TRACKED VEHICLES
E 109 Misc Instr No 1

CARRIER, ARMoured, TRACKED, 15-TON (FV 430 SERIES)

TECHNICAL HANDBOOK - MISCELLANEOUS INSTRUCTION

Fig 1 - Bracket l.h., slots counterboring

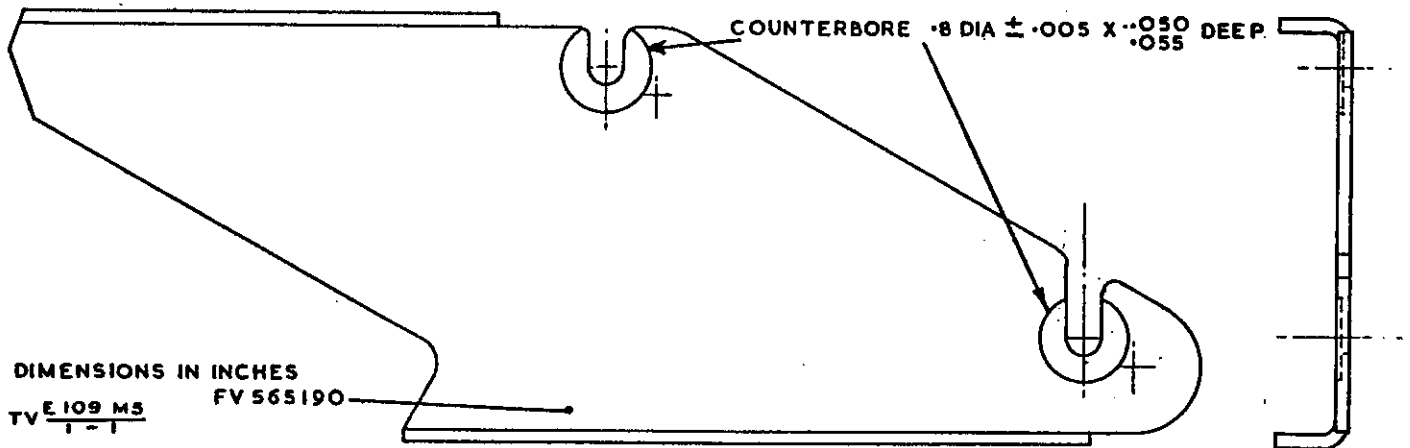
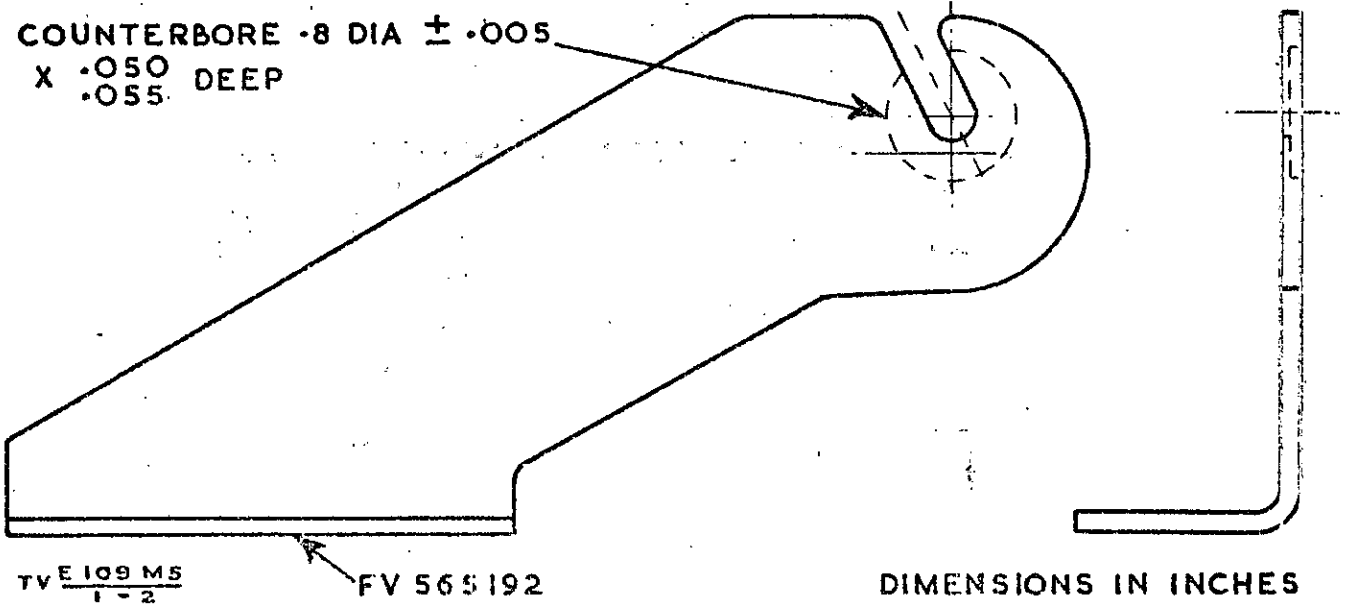
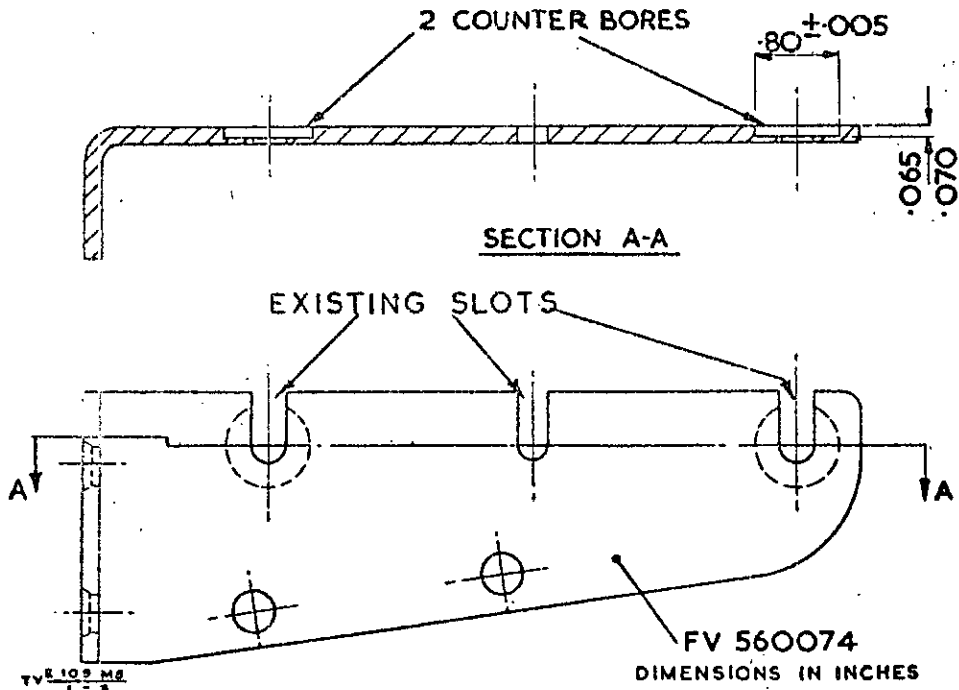
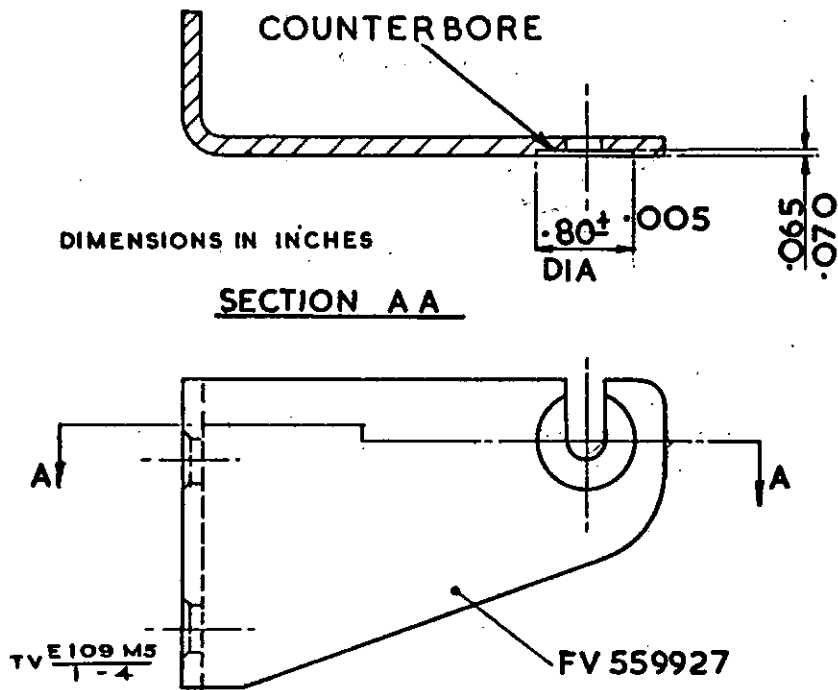
(1) Remove instrument panel mounting brackets l.h. and r.h. retaining the fixing items.

h. Refit instrument panel and secure wingnuts, ensuring that mounting spigots sit in counterbores.

Fig 1 - Fuel leak-off pipe - Assembly and clip details

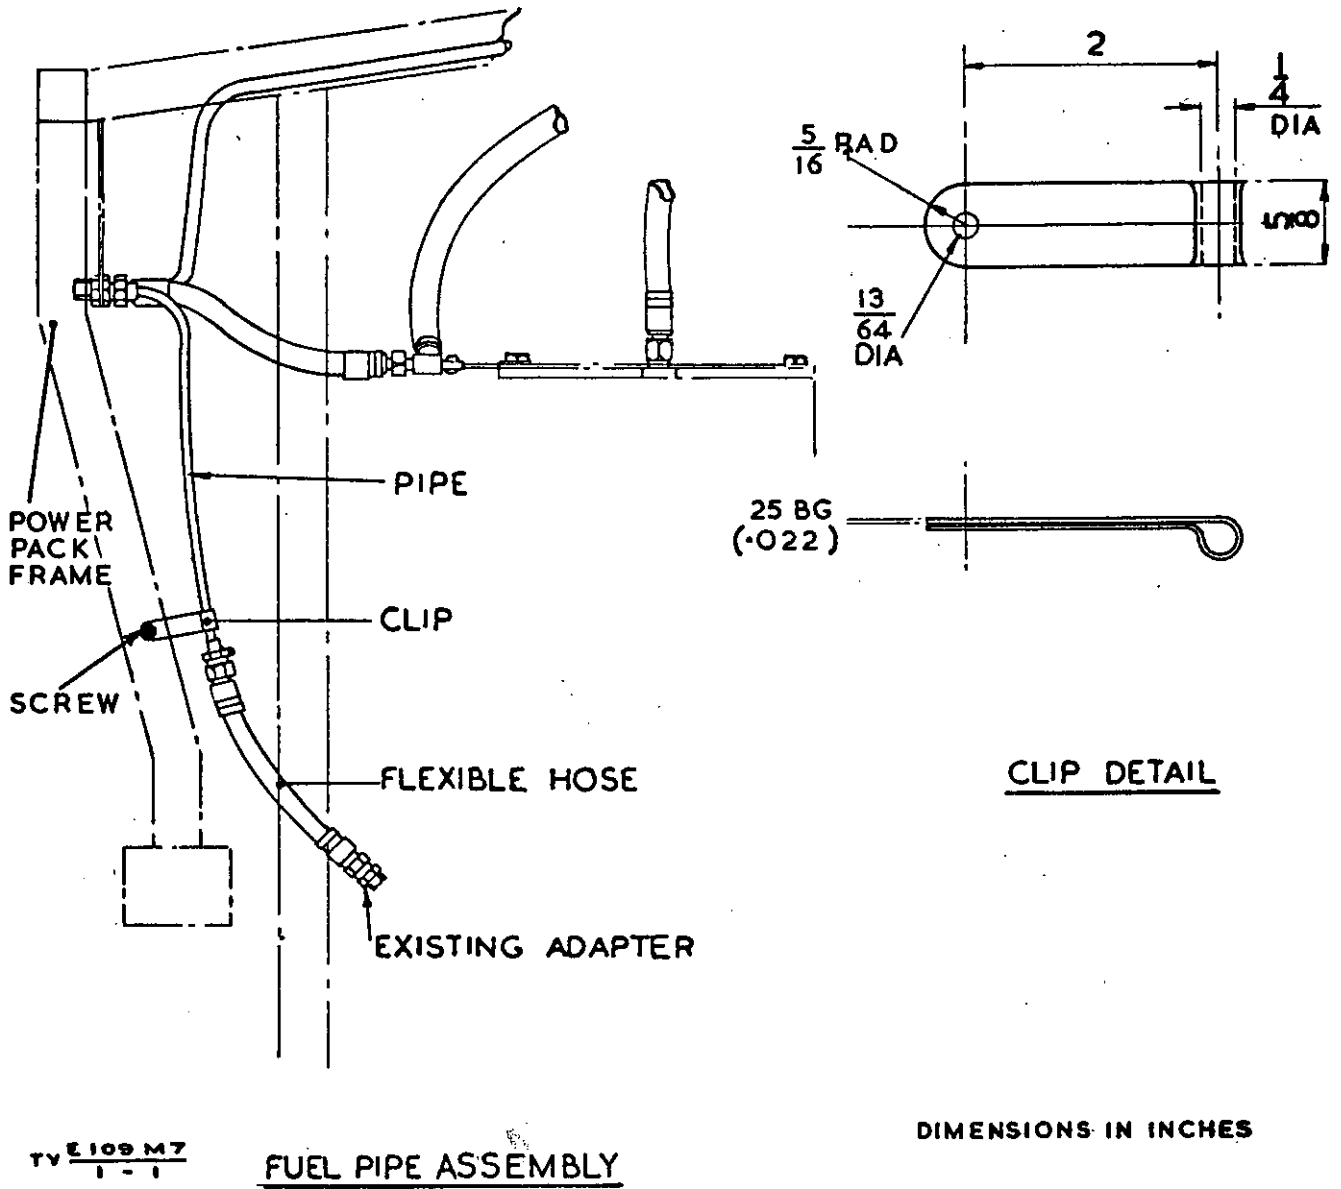
To improve installation of fuel pipes, the existing flexible leak-off pipe (FV 538507) is to be replaced by a two piece pipe (FV 602691, FV 602690) when stocks of former expire. Plate C8 of ISPL Army Code No 14660, items 63, 65, and 66 show this instruction embodied.

(1) Manufacture clip from material listed in para 4, to dimensions shown

(2) Fit replacement pipe assembly, consisting of pipe (4710-99-802-5249) (FV 602691) and hose (4720-99-802-5248) (FV 602690), and secure to power pack frame front upright using the manufactured clip and self-tapping screw, listed in para 4, as shown.

Fig 1 - Panel No 1 and No 3 assembly

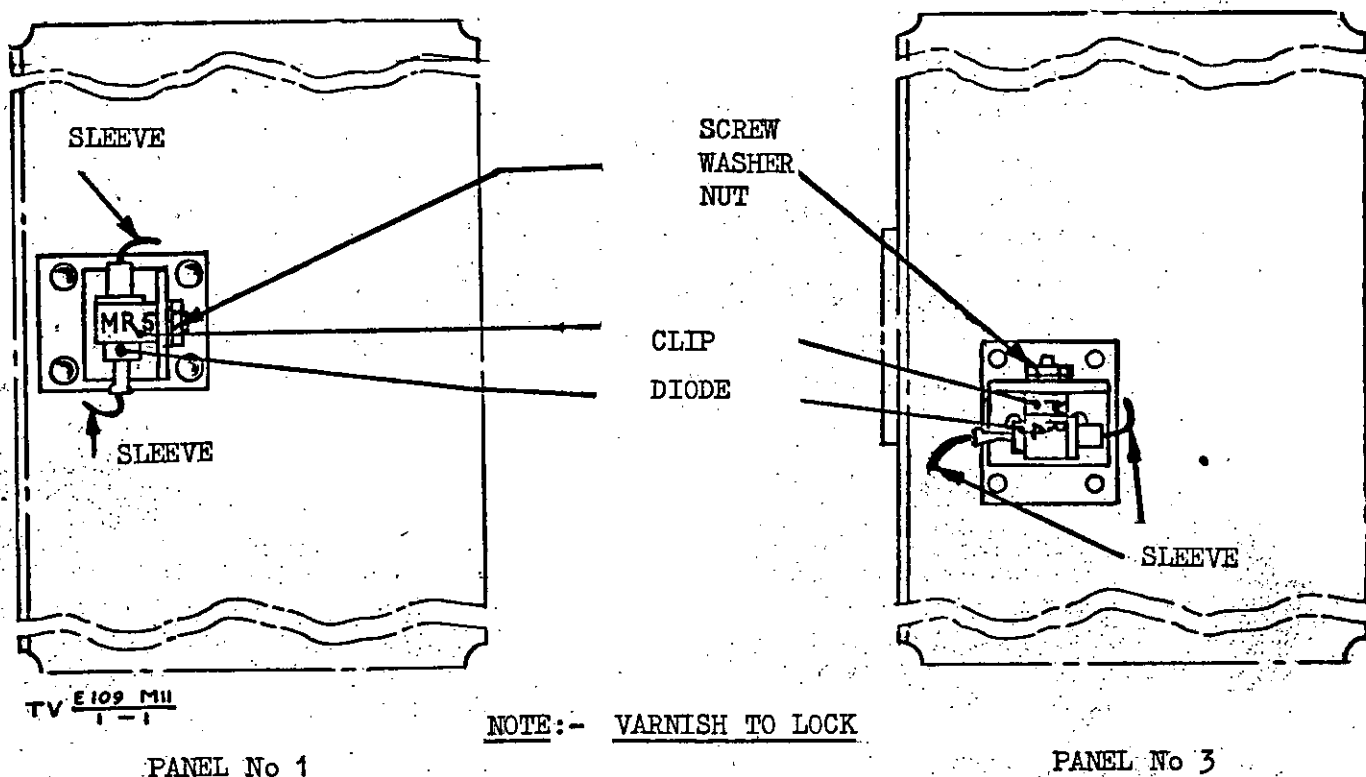
- a. Remove and discard the faulty diode (W 151056-6) (GV 7098) and 1/2mm bore sleeving from:-
- (1) Control panel No 1 (W 166454), item 17
 - or
 - (2) Control panel No 3 (W 168718), item 52
- b. See Fig 1: Fit the new diode (W 185910-14) to control panel No 1 or No 3, securing with the clip, nut, screw and washer listed in para 4.
- c. Fit the 1mm bore sleeving to diode wiring and connect up as shown.
- d. Check circuit.
